Marine Safety Center Vapor Control System (VCS) Plan Review Information Sheet (PRIS)

| Vessel Name | CBC90 | Shipyard | Jeffboat |
| Official Number | 1141494 | Hull Number | 03-2972 & 03-2977 |

VCS Approval Letter C1-0304452 dated 25Mar03 MSC Plan Reviewer LTjg Hsing-Yen Fu

LIQUID TRANSFER RATE VS FACILITY VAPOR CONNECTION PRESSURE

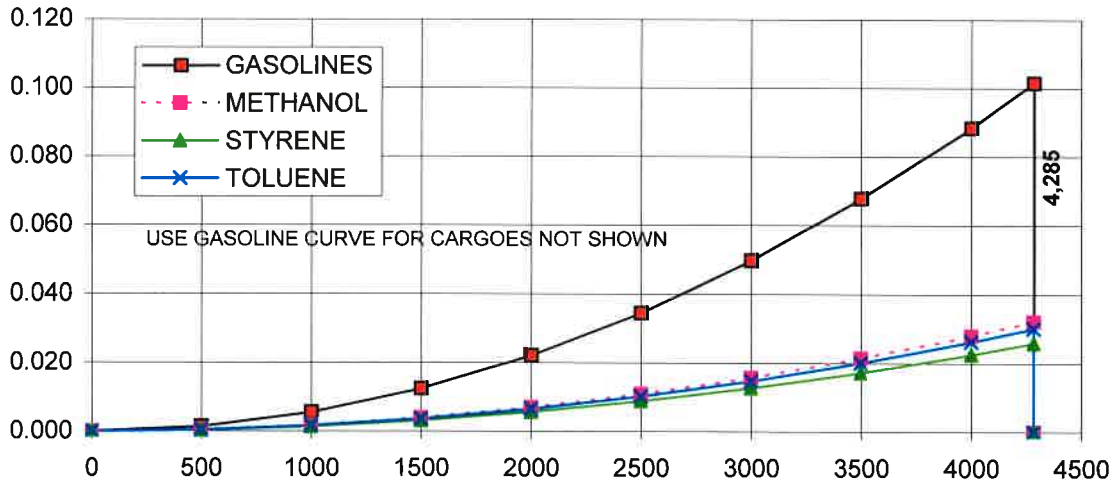
9c. Verify isolation valve at the vapor connection flange is manually operable and designed in a way it is "clearly" open or closed.
